## EVERSTEAD SHOP DRAWINGS/SUBMITTAL REVIEW

J BLE AT :S, RK H	2826819	SUMMIT HOMES - WINFIELD #127	3208 ARBORTREE DR	LEE'S SUMMIT. MO
	ı	ı	ı	1

ROOF TRUSS LAYOUT

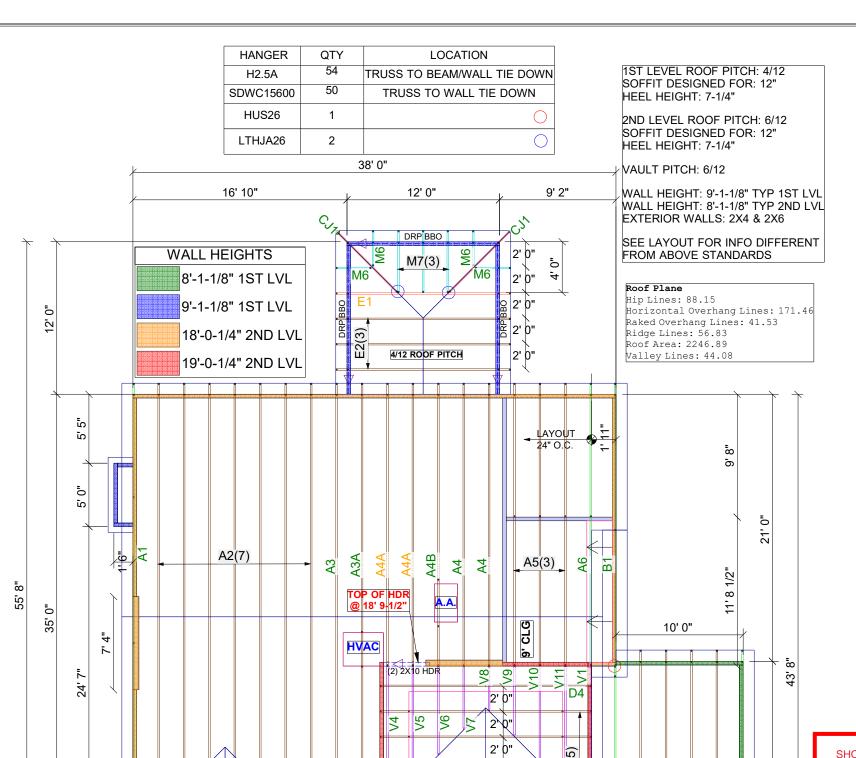
## **APPROVED**
